CITY OF ALBUQUERQUE

Re: Lot 15 Block 4 Unit 22 SAD 228

6423 Canavio St. NW

Request Permanent C.O. - Accepted

6423 CANAVIO PLACE DRAWN ENGINEER'S BY WCWJ SEAL 4-26-17 GRADING AND DRAINAGE PLAN 21731-LAYOUT-4-26-1 SHEET # Rio Grande Engineering

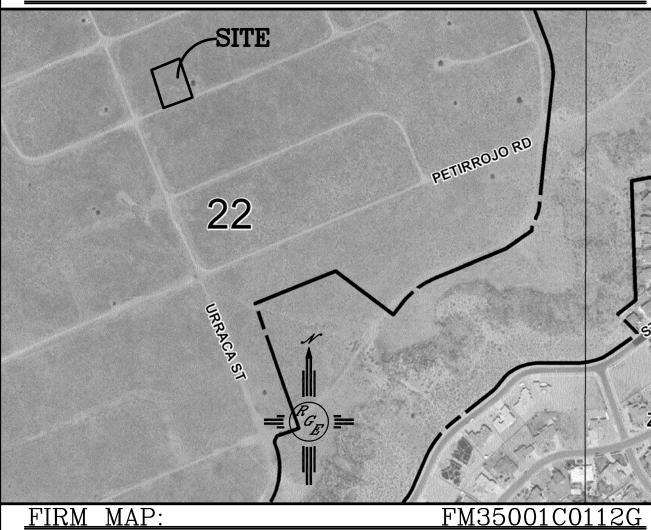
Based on the Certification received 11/29/2017, the site is acceptable for release of Certificate of Occupancy by Hydrology.
